CITY OF PORT PHILLIP
PORT PHILLIP PLANNING SCHEME
SECONDARY CONSENT APPROVAL
under Condition No. 2 in Planning Permit No: 742/2020
Note: This approval relates to ther indicated/highlighted area(s) only
Date: 6/09/2022 Sheet: 1 of 16

SCHEDULE OF CHANGES BY POINT ARCHITECTS DATED 21.04.2022 IS AS FOLLOWS:

POINT ARCHITECT'S RESPONSE TO THE PERMIT CONDITIONS DATED 14.01.2022 IS AS FOLLOWS:

1 ELEVATION - NORTH
TP200 SCALE 1 : 100

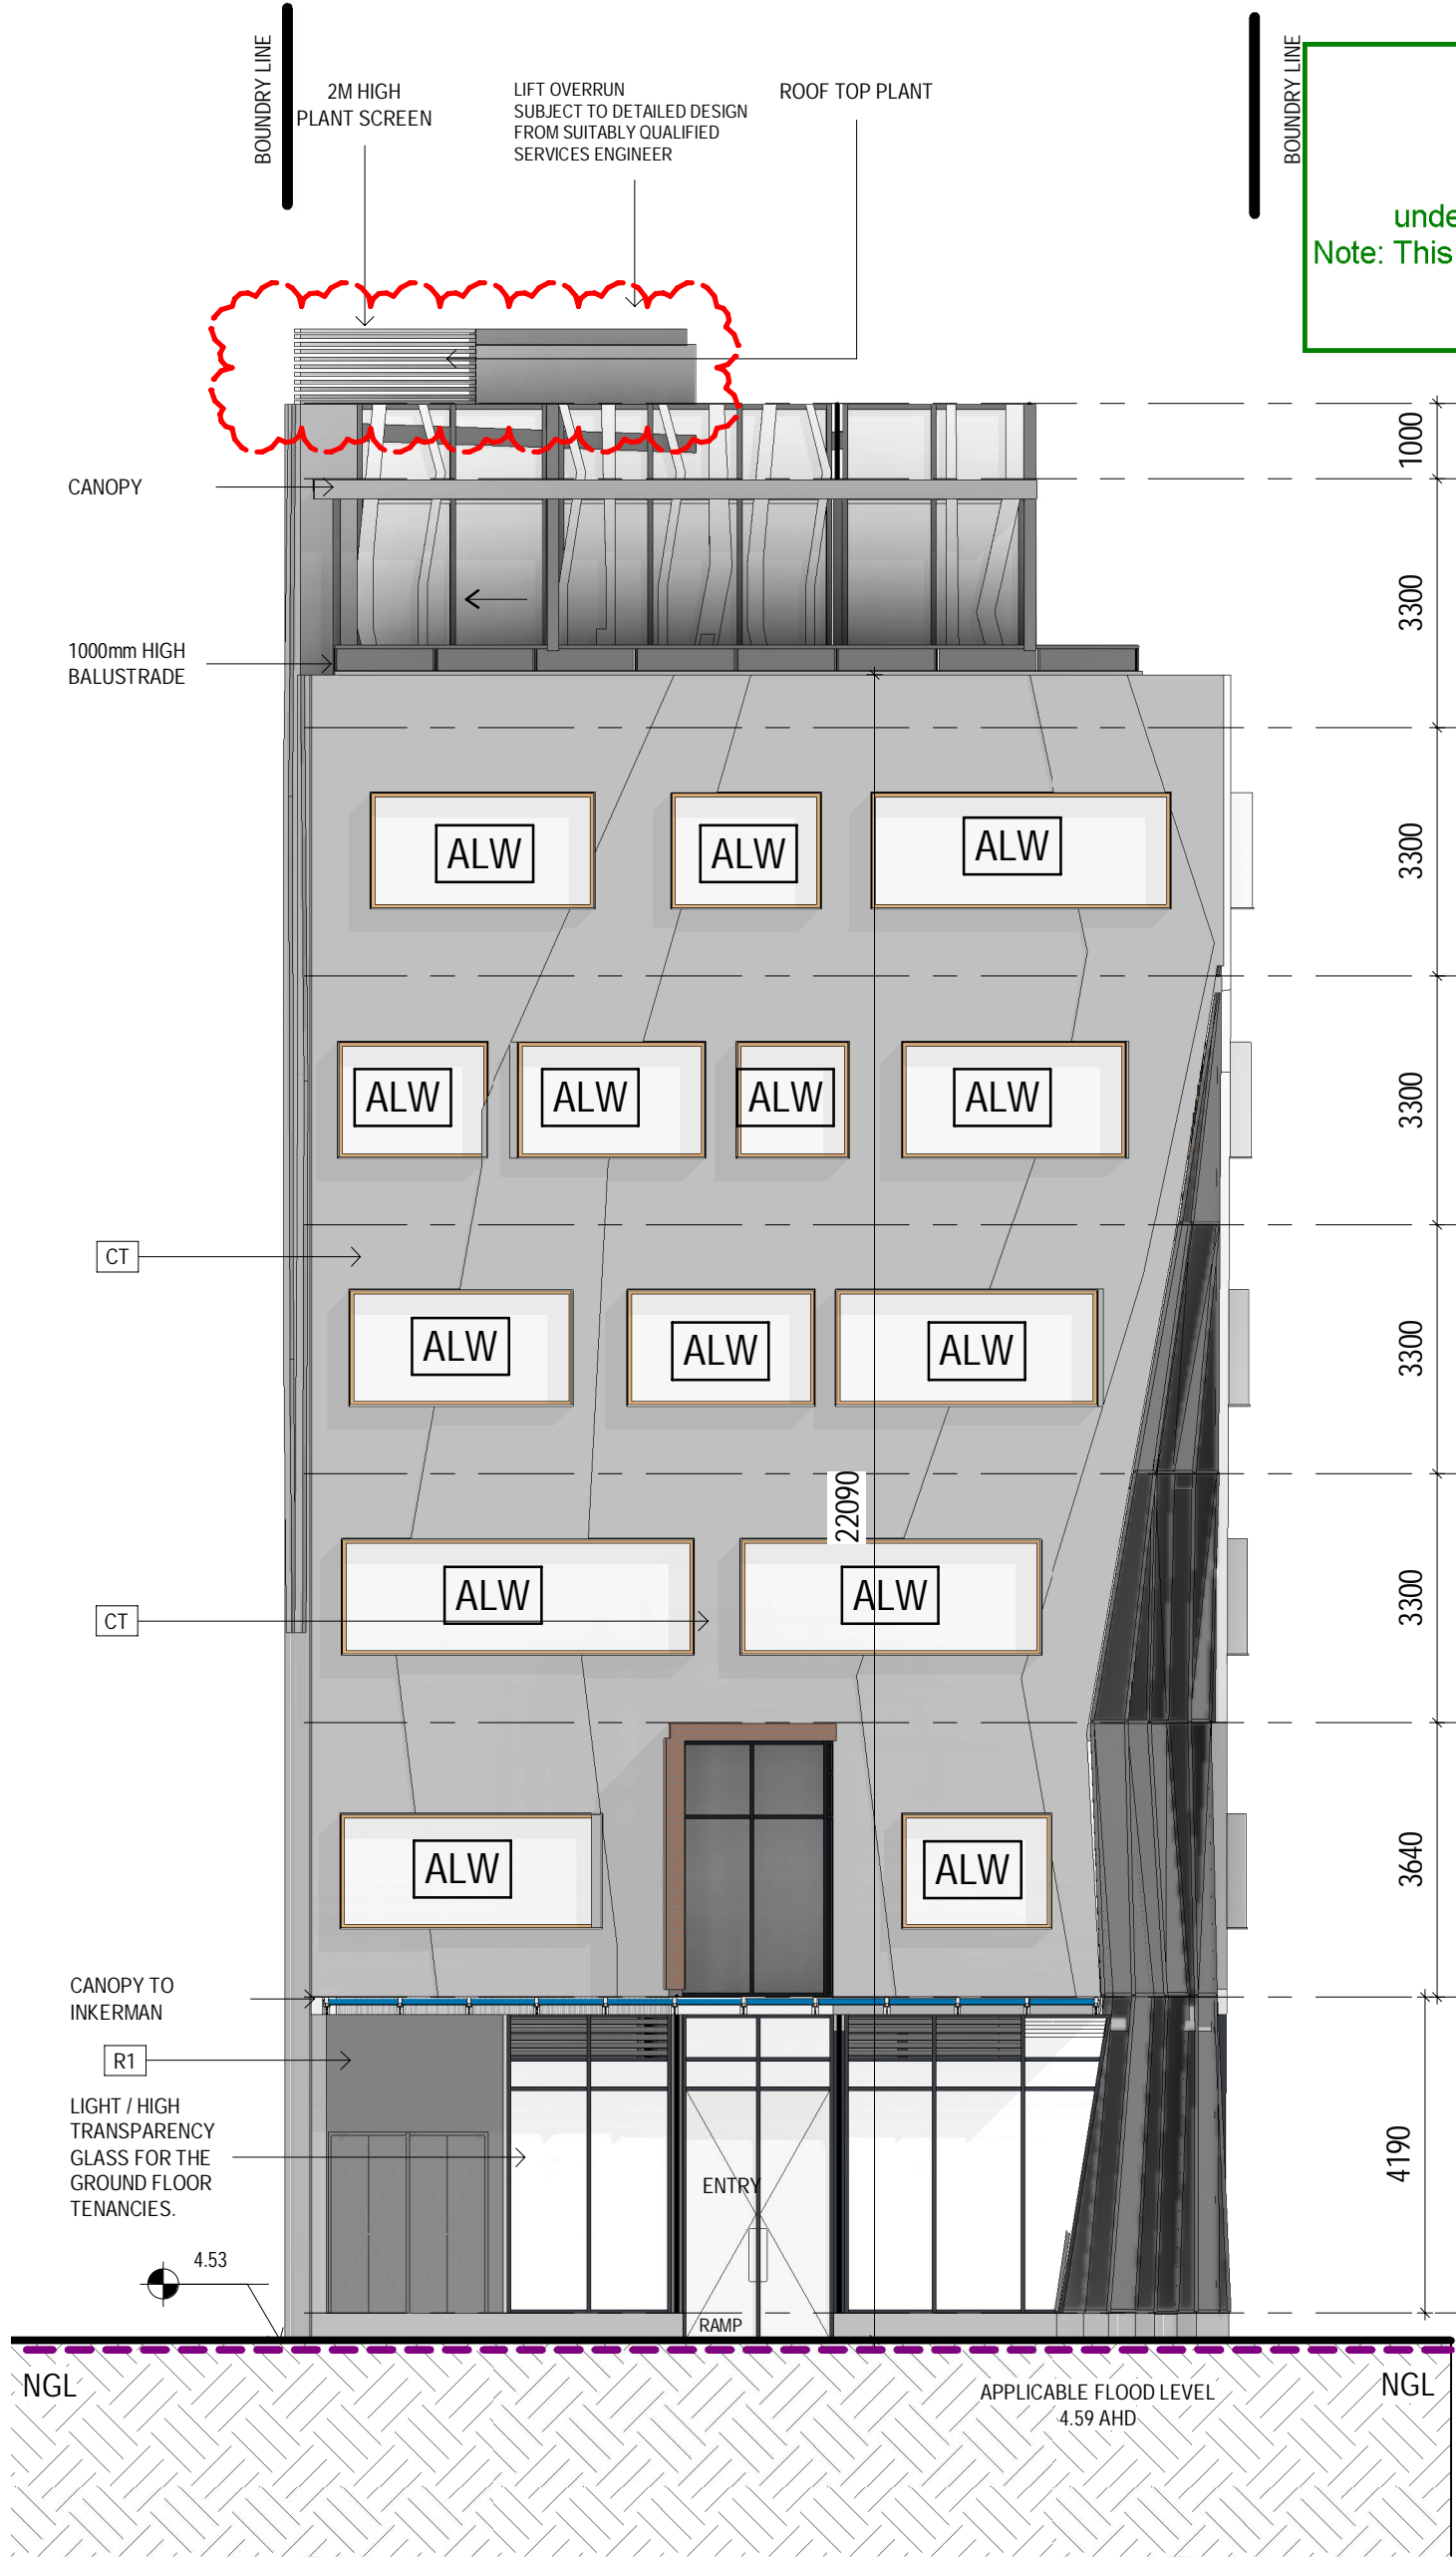
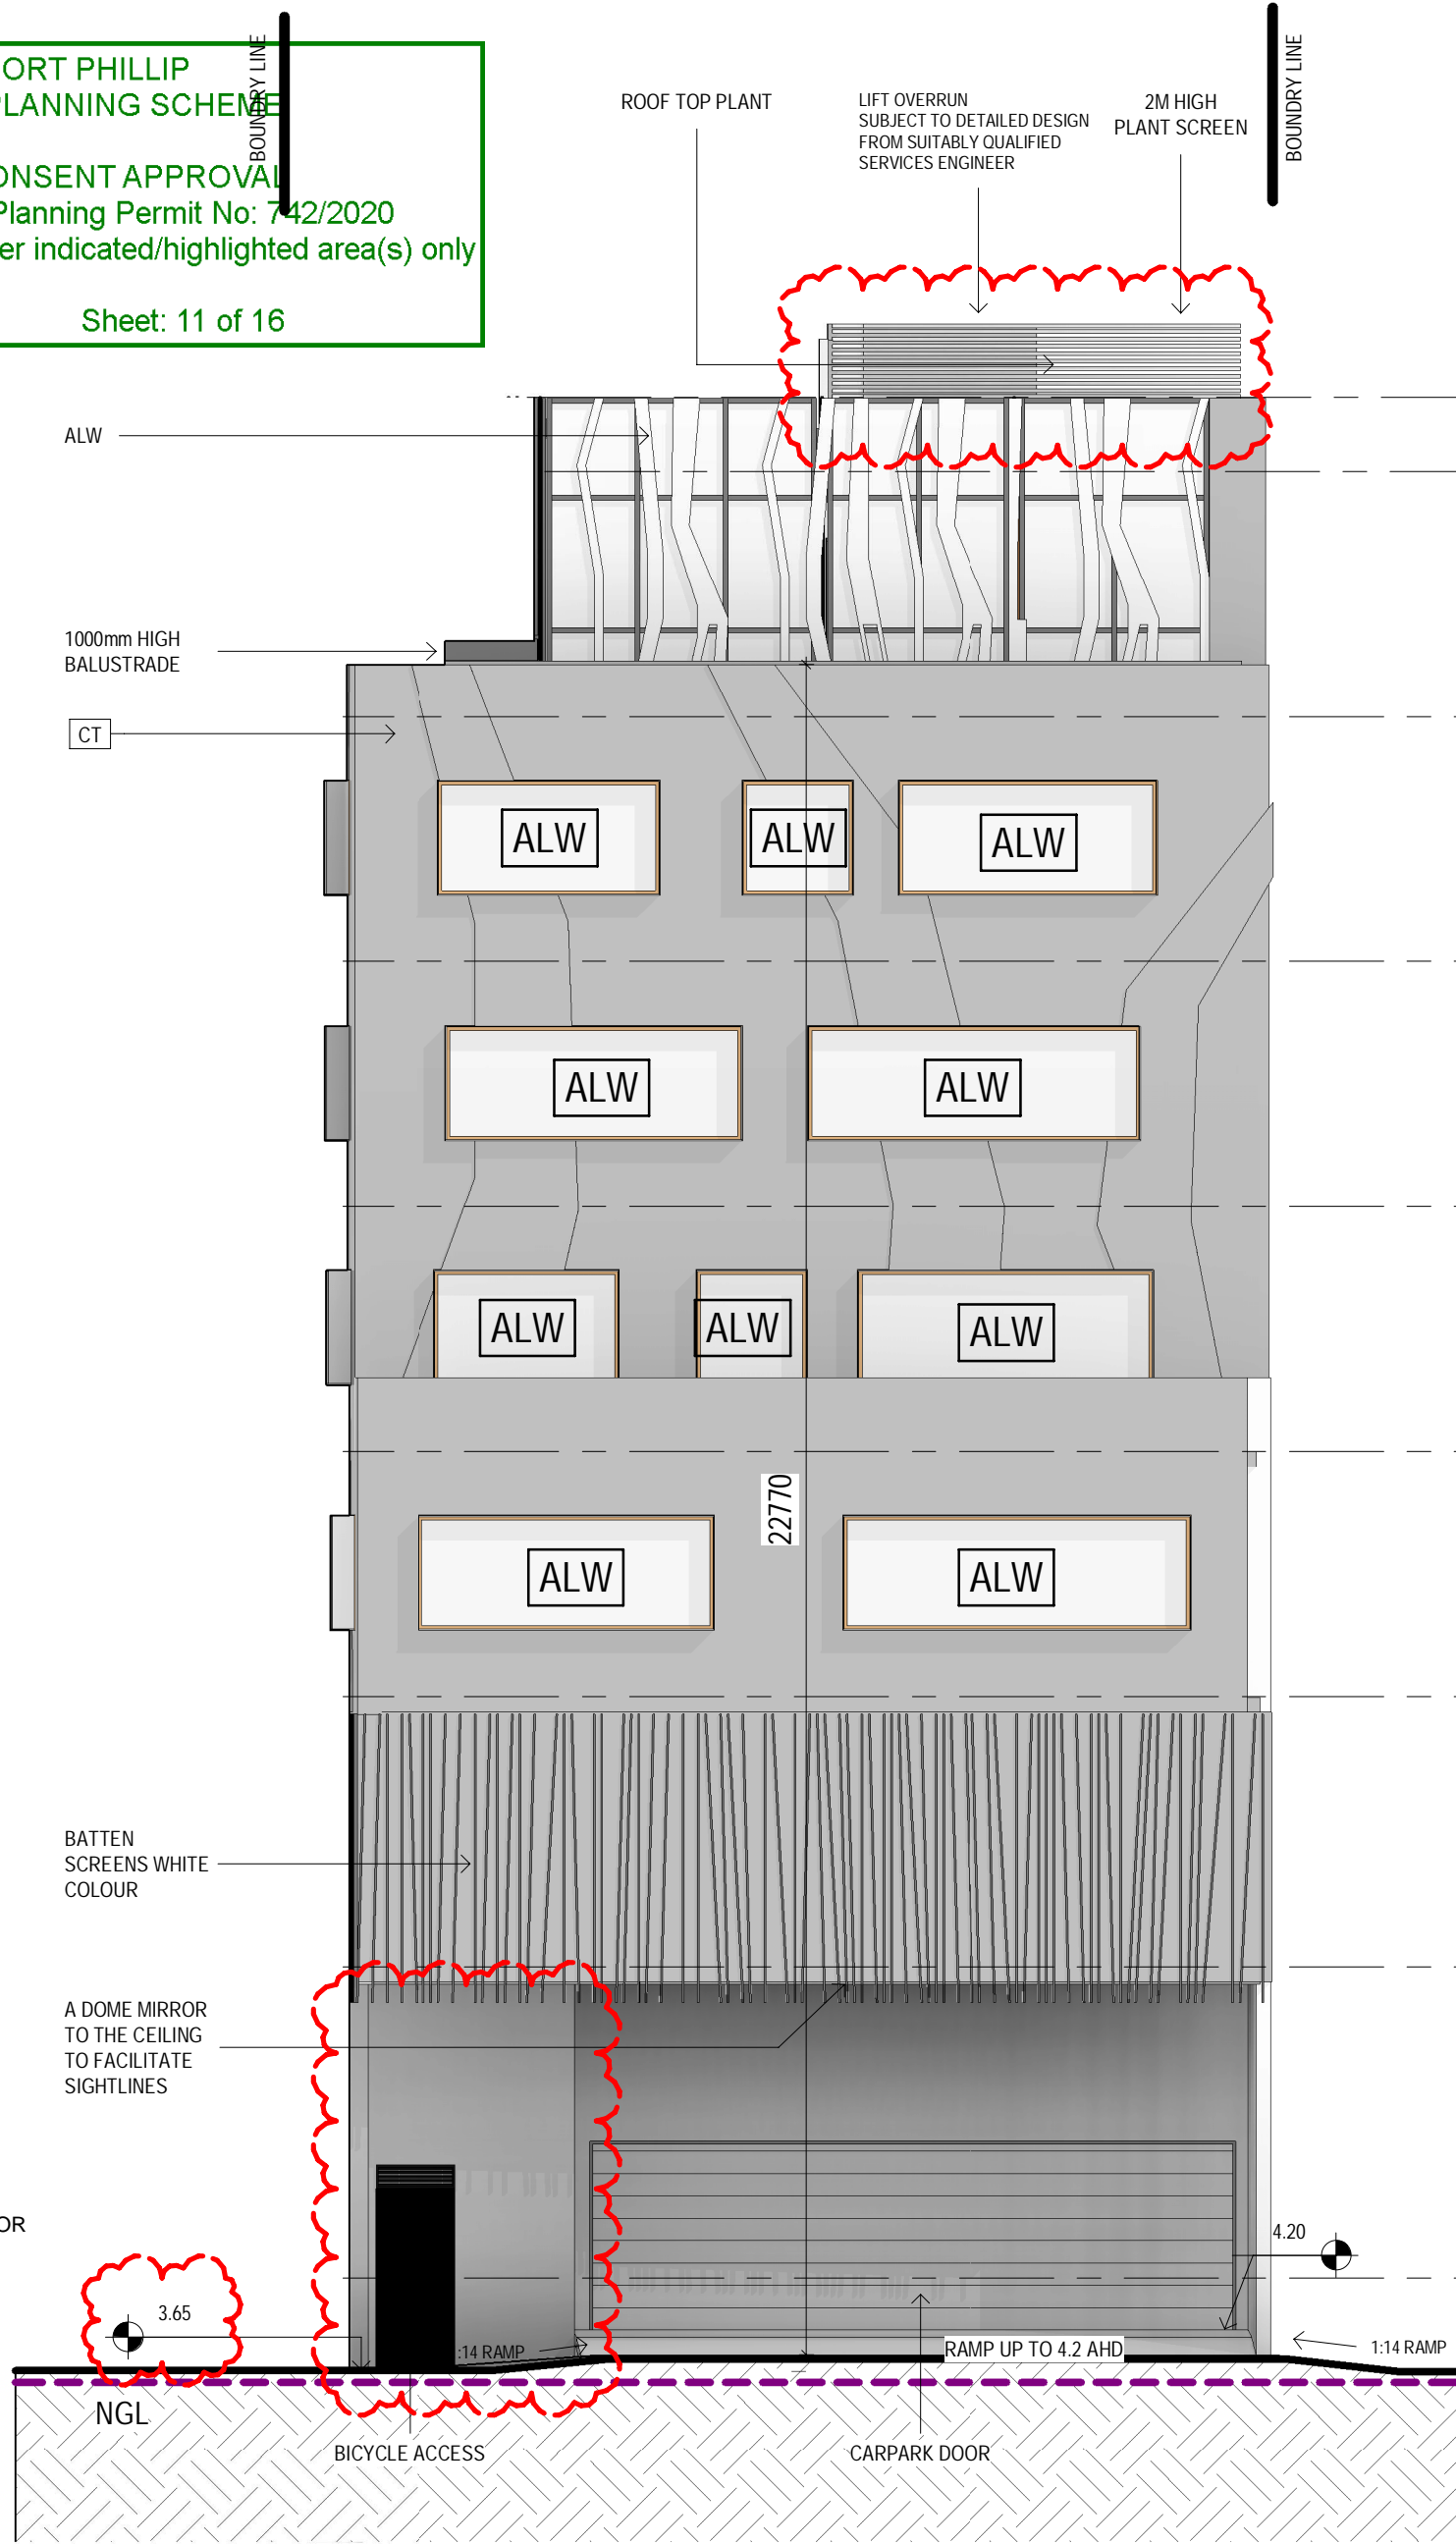
- ROOF ACCESS RELOCATED TO SUIT RECENT LIFT AND STAIR CHANGES
- TP200-202 - PROPOSED ELEVATIONS
 - LIFT OVERRUN AND PLANT AREA RECONFIGURED TO SUIT RECENT CHANGES

CONDITION 1(a) Use of light/high transparency glass for the ground floor tenancies
RESPONSE: Note added to TP 100, TP 200, TP 201 and TP202 to ensure use of light / high transparency glass for the ground floor tenancies

NOTE:
USE LIGHT /HIGH TRANSPARENCY GLASS FOR THE GROUND FLOOR TENANCIES.

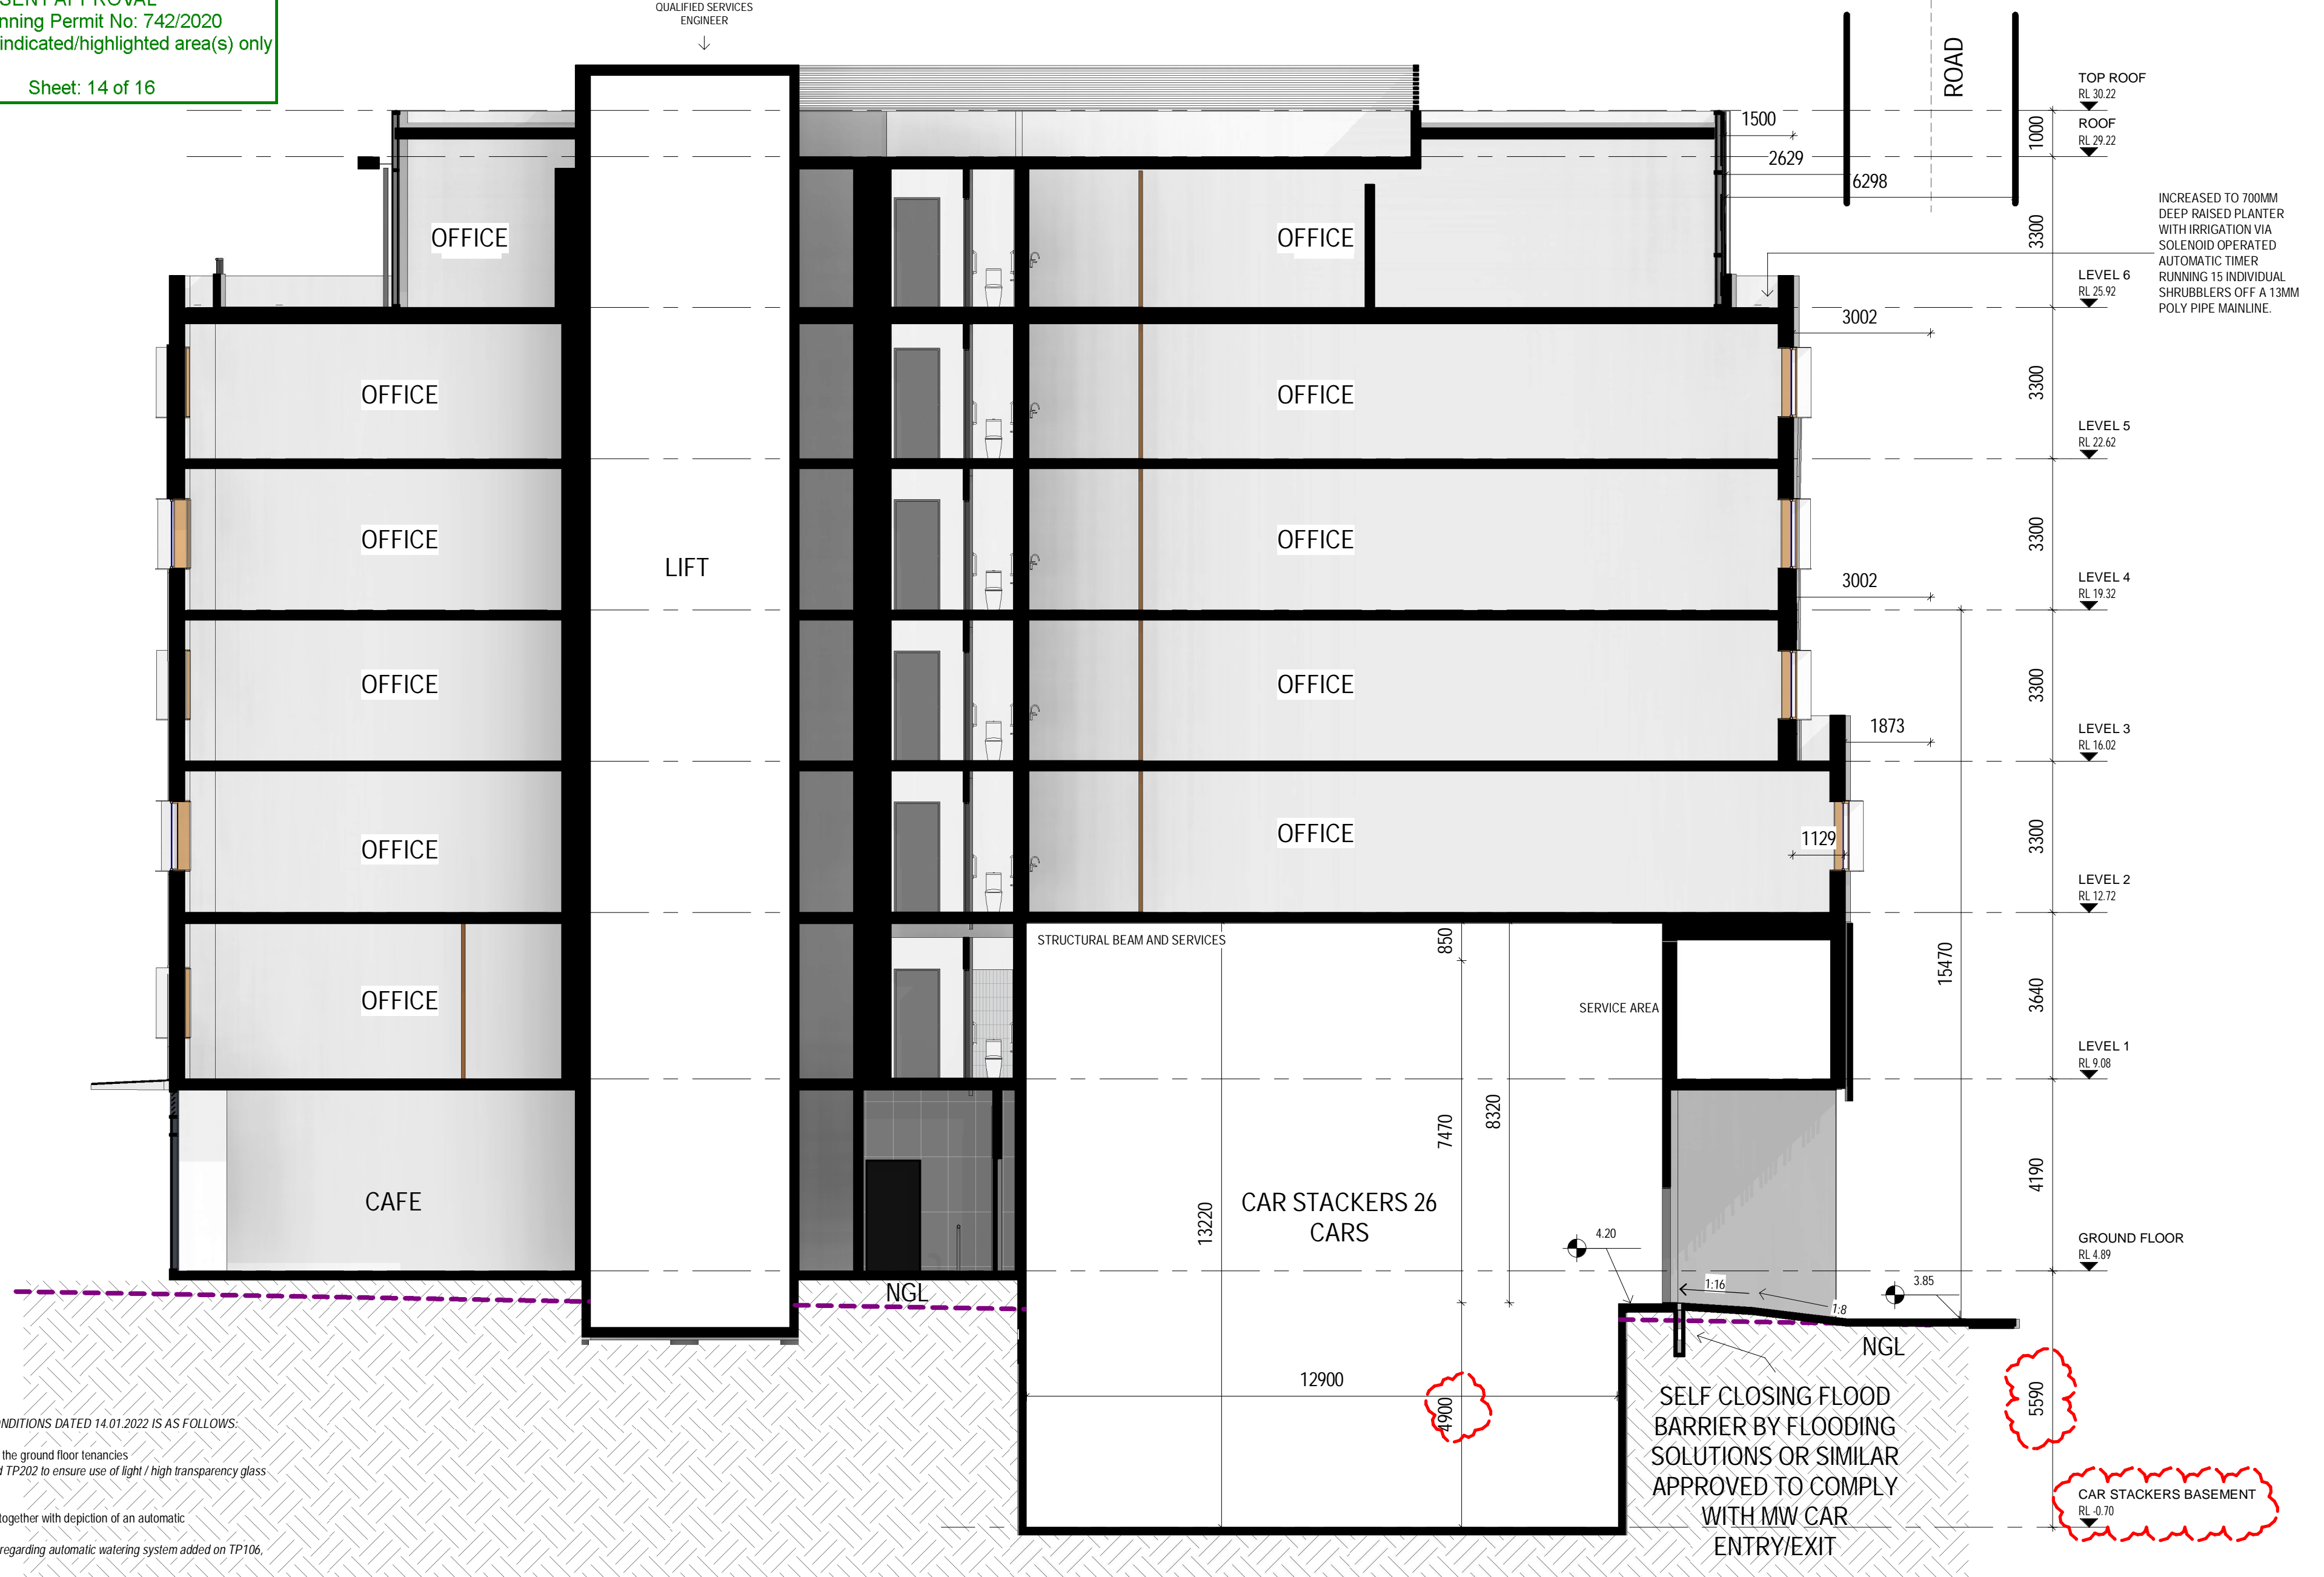
CONDITION 1(c) Depiction of lift overruns and plant areas on the elevations.
RESPONSE: Plant screen and lift over run depicted on TP 107, TP200, TP 201, TP202, TP203, TP204 and TP205.

LIFT OVERRUN
SUBJECT TO DETAILED
DESIGN FROM SUITABLY
QUALIFIED SERVICES
ENGINEER
